No.: MC/ACF/Fire Detection/AC

Sub: Location for fitment of automatic Fire and smoke detection system (FSDS) in AC coaches.

Accordingly, based upon the suggestions from PU's/Zonal Railways and deliberations with suppliers of FSDS systems, it is advised that FSDS should be fitted in following locations of coaches:

NOTE: Above standardised location supersedes the instructions of RDSO letter no. MC/ACF/Fire Detection/AC dated 02.02.2024.

For AC-2Tier & AC 3-Tier

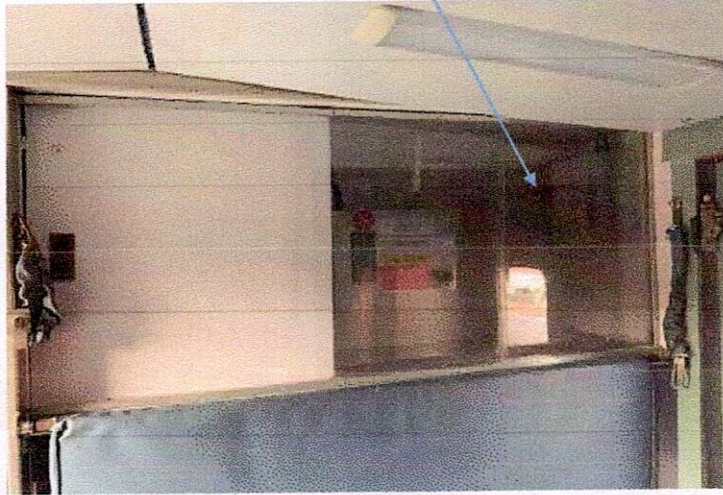
2.	2 nd AC	in linen room (NPP Side) as per drawing no. AHT-ASD-102 alt-Nil	Proposed to fit all Electronics equipment items like FSDS, CCTV and PAPIS system in equipment rake (metal) in place of door side linen room (new coaches) at NPP side linen i.e. (535X690 for 2 nd AC and 520X575 for 3 rd AC) as per drawing no. LW90056 alt-Nil (2 nd AC) and LE90050 Alt-'a' (3 rd AC)	in linen room NPP side	SR prepared drawing (SR.SK. No. C&W 4262/BG) with partition and transparent opening with acrylic sheet for visibility of indication in existing FSDS system as per Annexure-II

ENCLOSURE FOR FDS IN 3-TIER LHB COACH

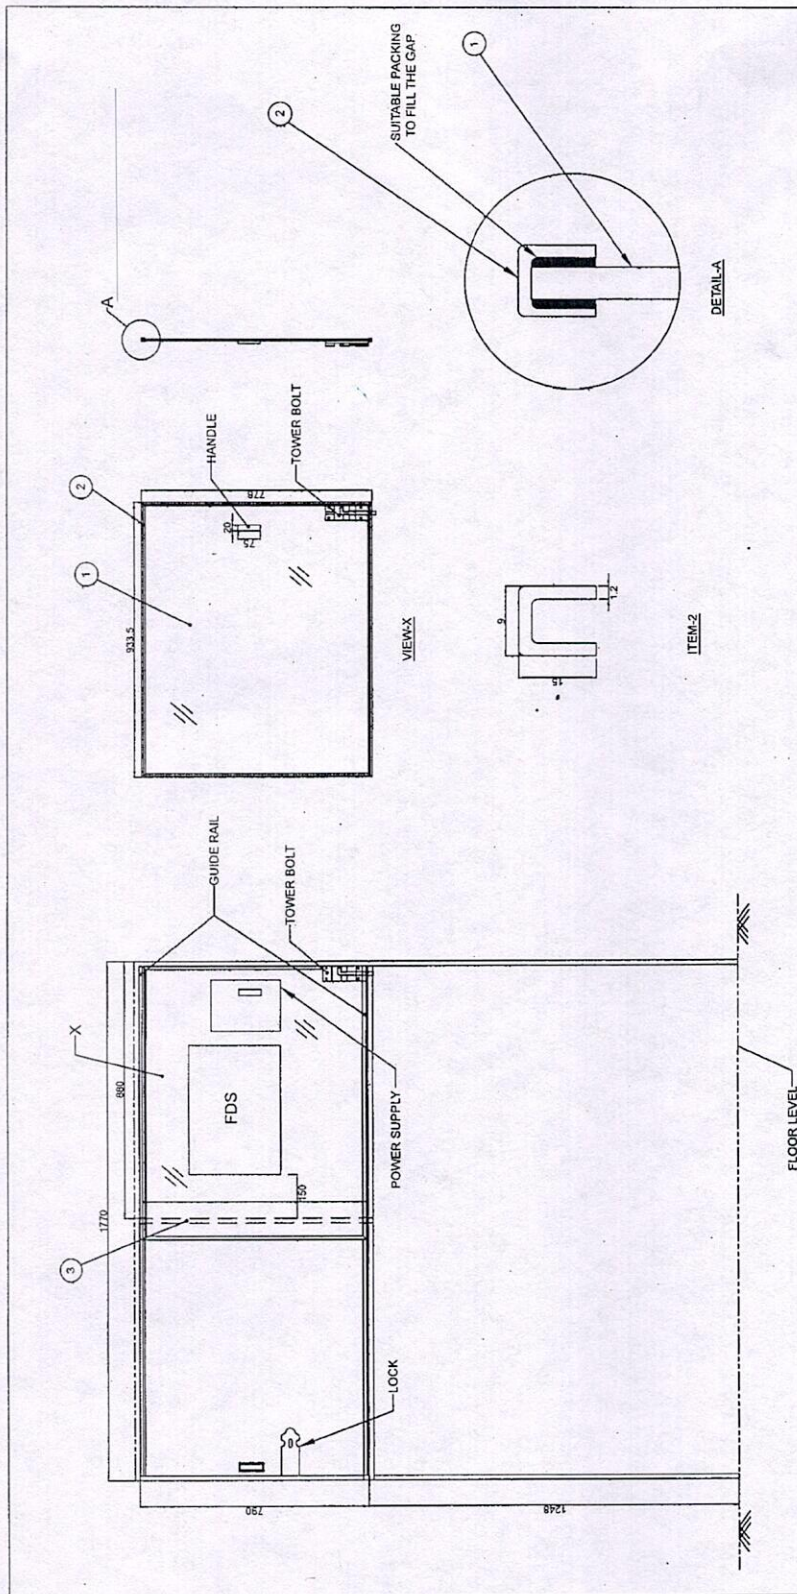
3.	3 rd AC	in linen room (NPP Side) as per drawing no. AHT-ASD-101 alt-Nil			(i) SR prepared drawing (SR.SK. No. C&W 4261/BG) to provide partition in existing linen room with transparent opening by acrylic sheet for visibility of indication in existing FSDS system so that it would not have any hindrance with linen room. (ii) Another alternate location for provision of FSDS in linen room 520X575X2000 of NPP End by removing 3 partitions in existing room and fixing FSDS system by providing two partitions as per drawing no. 767-9-0-201. (iii) It is not desirable to fit FSDS on Lavatory module wall above dust bin on PP side.

1. ALL DIMENSIONS ARE IN mm.
2. ALL SHARP EDGES SHOULD BE ROUNDED OFF.
3. LOCK TO BE FIXED 150MM FROM PARTITION BOARD.
4. REF. DRG. FOR 3-TIER LHB 4112, CS55271 & LBS109.
5. TOWER BOLT & HANDLE SHOULD BE FIXED ON ACRYLIC SLIDING DOOR WITH NUT & BOLT AT SUITABLE LOCATION.
6. PARTITION BOARD TO BE FIXED WITH SUITABLE BRACKET.
7. EXISTING SLIDING DOOR TO BE REPLACED WITH ACRYLIC SLIDING DOOR ARRANGEMENT.

LOCATION OF FSDS IN FIRST AC COACHES

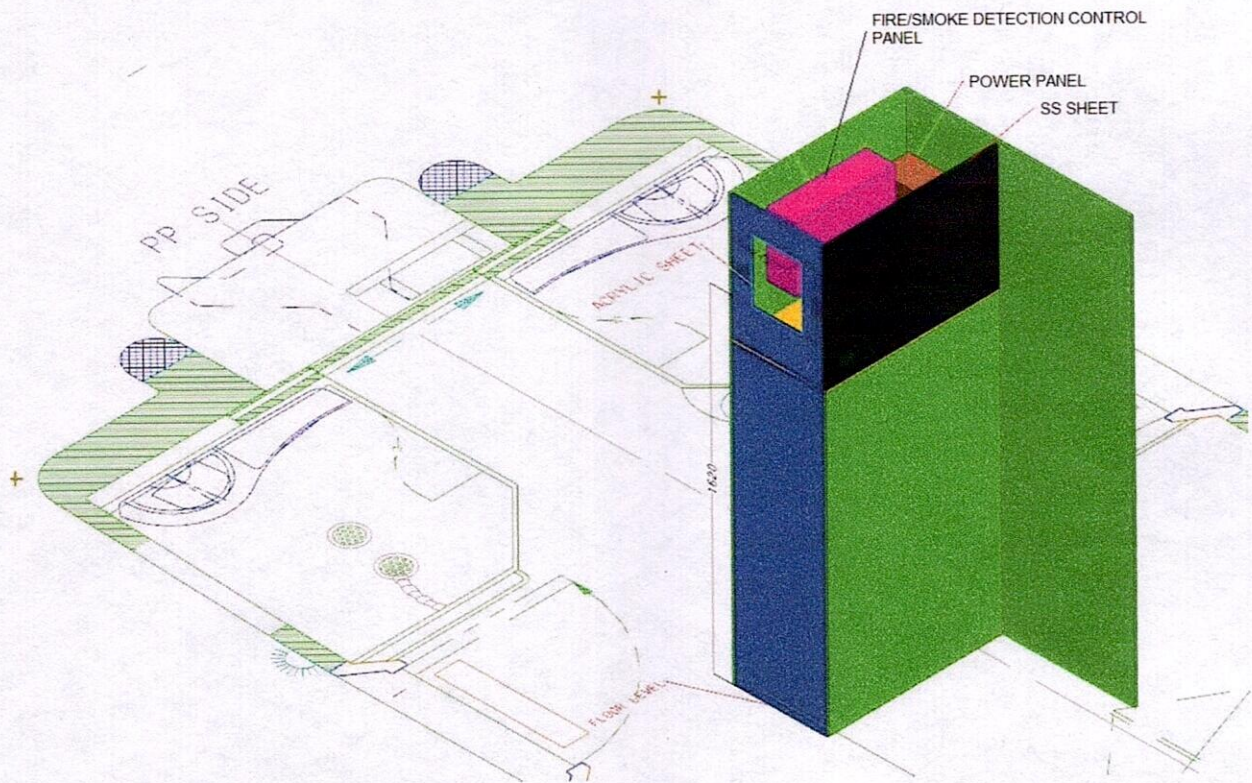
S. No.	Coach type	Standardised Location of FSDS system
1.	1 st AC	Separate enclosure in attendant cabin on PP side with provision of door having transparent opening by acrylic sheet.
2.	2 nd AC	Separate enclosure in linen room (above attendant berth on NPP side) with metallic partition frame and transparent opening with acrylic sheet for visibility of indication of FSDS system.
3.	3 rd AC	
4.	3 rd AC Economy	Existing location beside electrical cabinet (SBC panel) with transparent opening with acrylic sheet for visibility.
5.	AC Chair car	Separate enclosure with metallic partition frame opposite to pantry equipments on PP side with transparent opening with acrylic sheet for visibility.
